Planning Commission

Regular Meeting Agenda

Frances Meaders Council Chambers
151 Willowbend Road
March 24, 2025 | 6:30 PM

SUBJECT: Conceptual Site Plan, Warehouse and Office, 1601 Moba Drive

PAINTED BOLLARD - SHERWIN WILLIAMS
COLOR: SW7017 DORIAN GREY
- 7

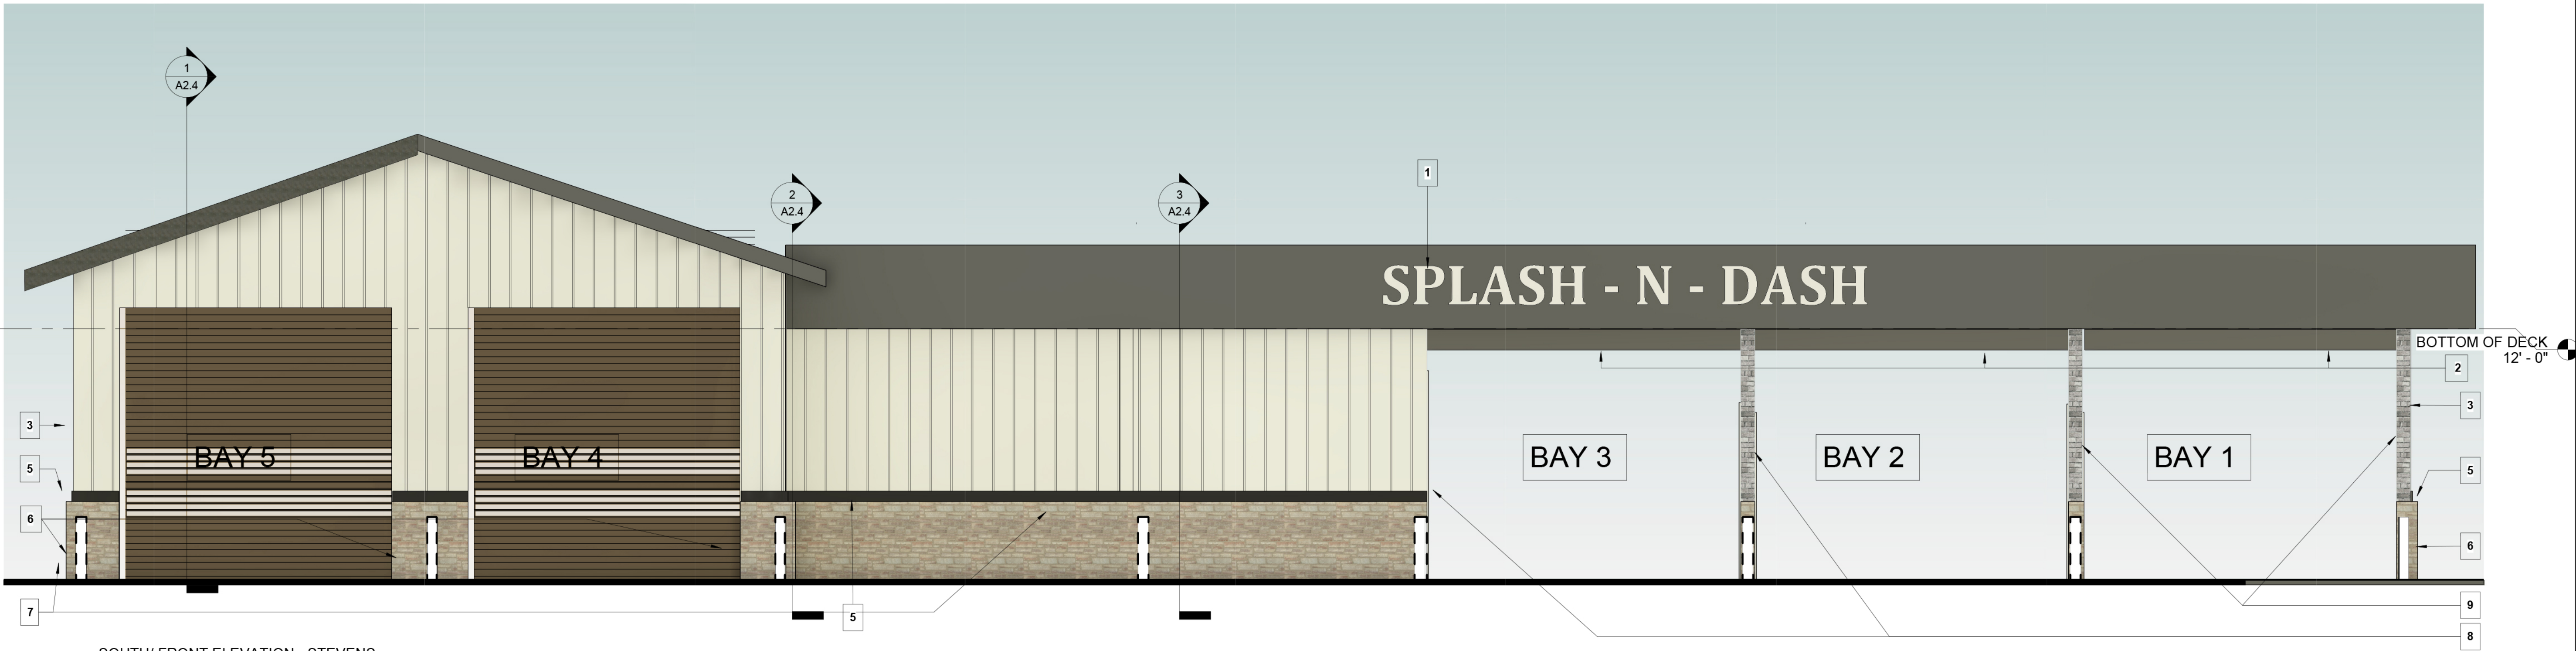
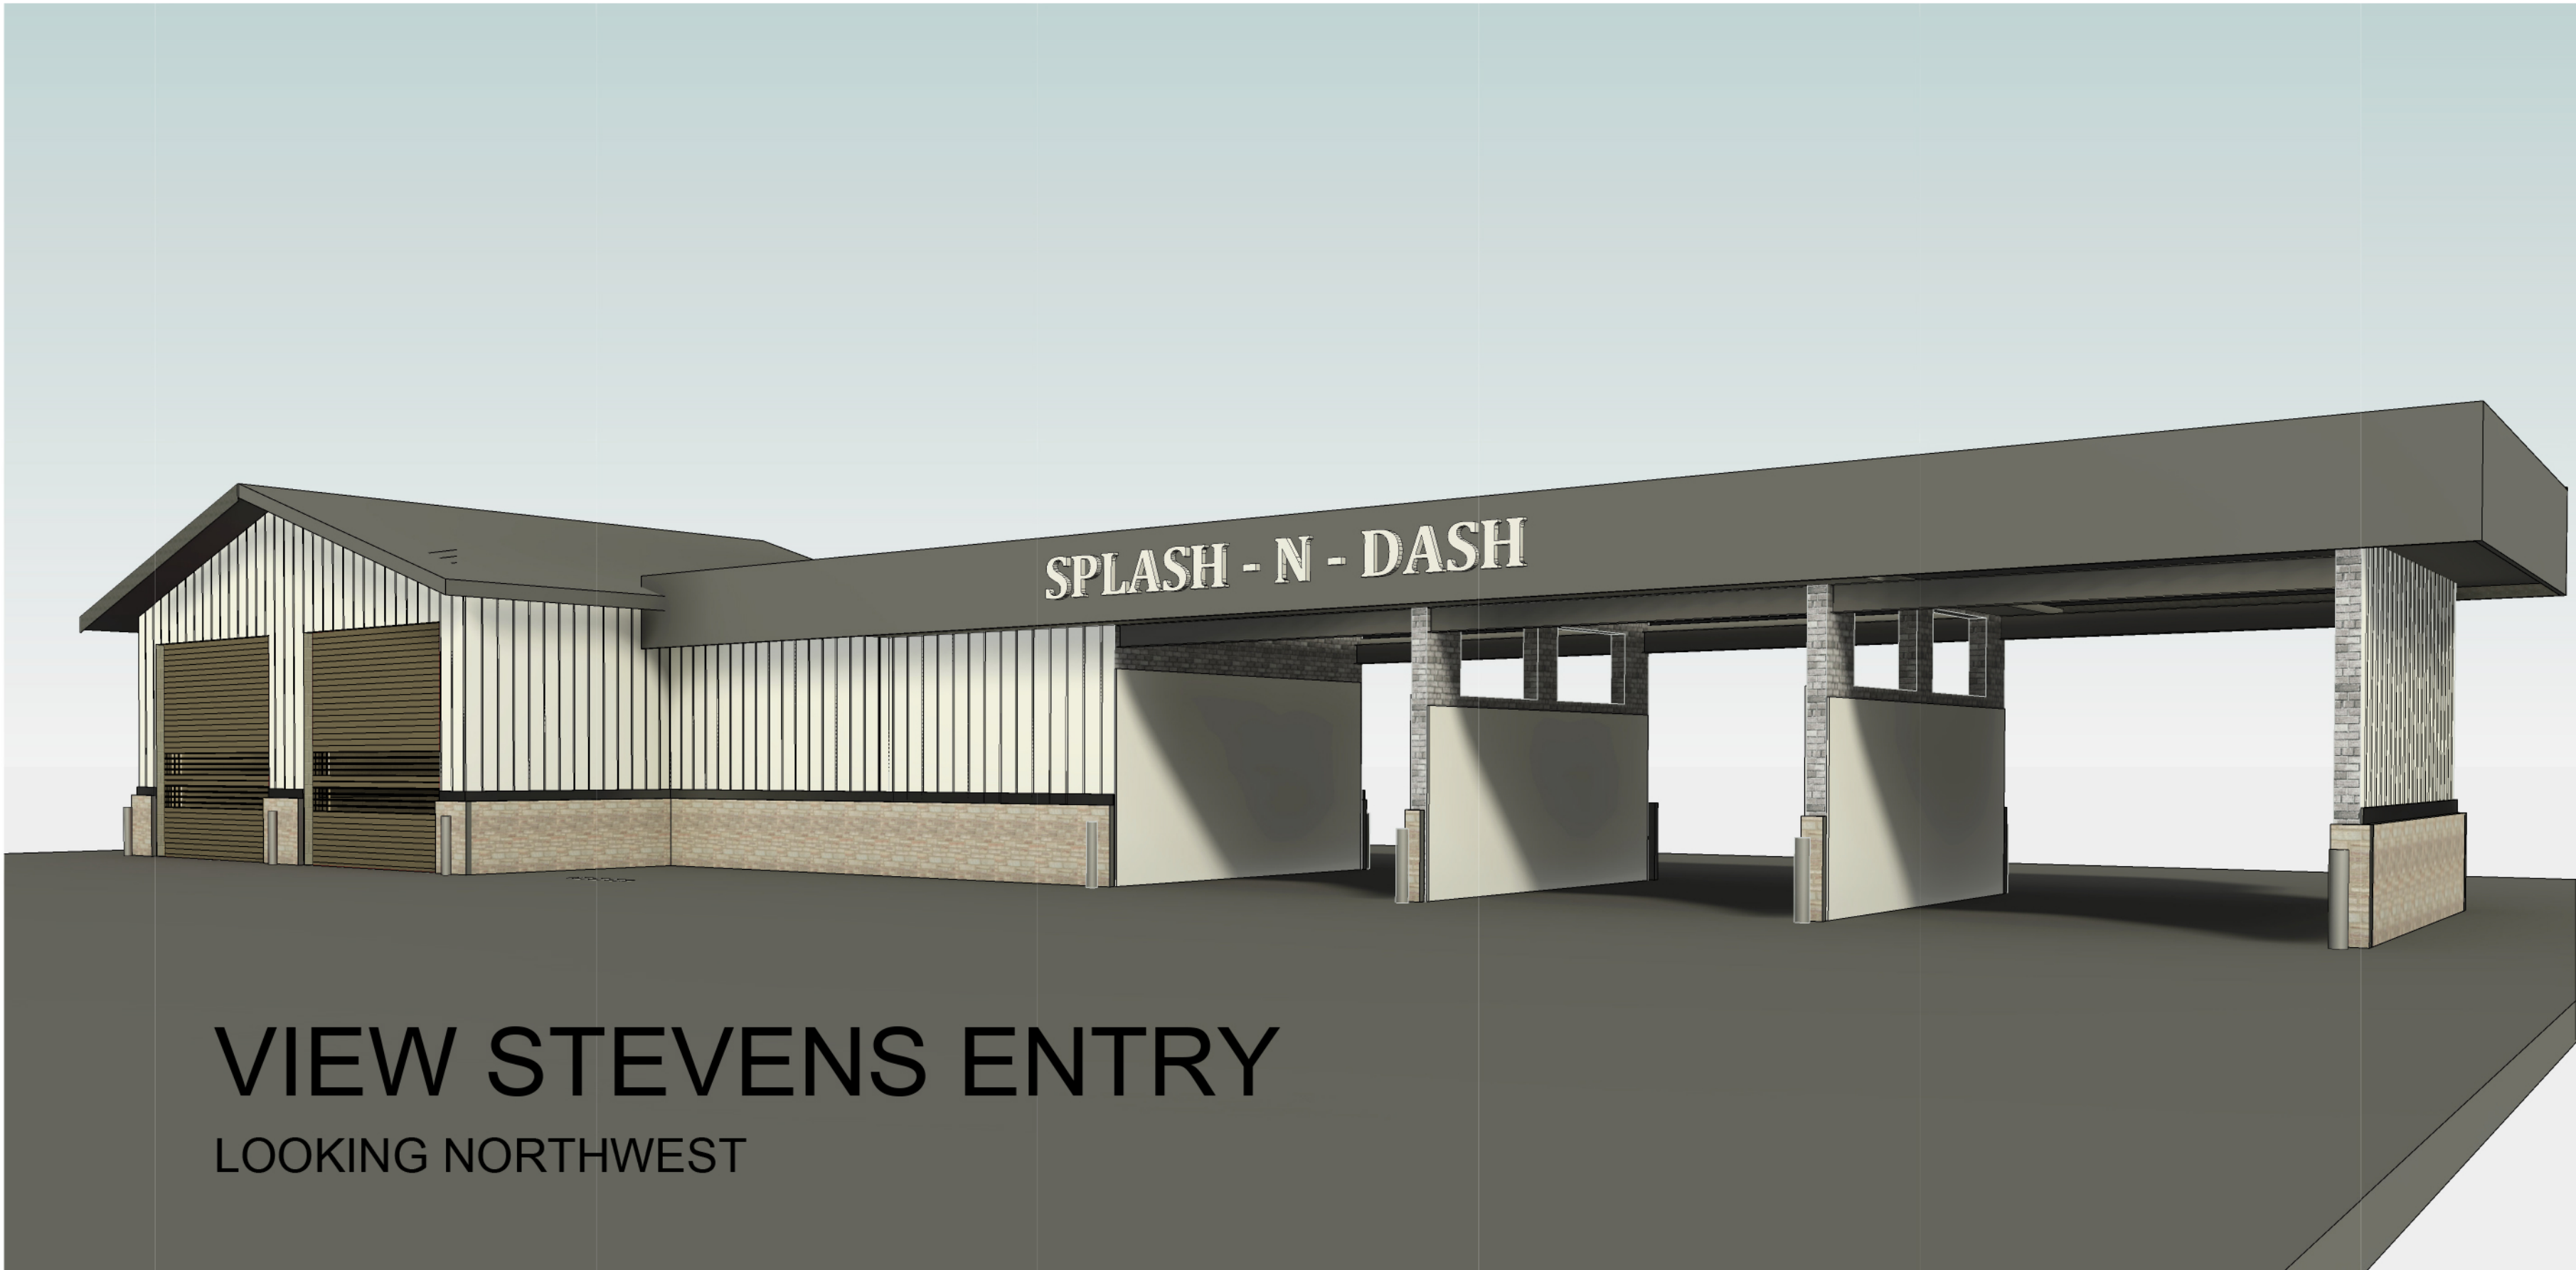
While the proposal to upgrade the car wash satisfies the majority of the City's design standards and enhances the visual appearance of the community, section 728 of the Land Development Ordinance states that natural brick "should" not be painted.

As a general rule, front facades should be 80% primary materials and side facades 50% primary materials. Technically, the site has two fronts. Shifting the automatic wash bays to the end cap and fully enclosing them has increased the amount of primary materials. The facade facing Stevens Entry is made up of 58% primary materials, the west side facing Prime Pt. is 100%, and the east side 81%. Staff feels Hardi board is a quality durable material and meets the intent of the ordinance for primary materials.
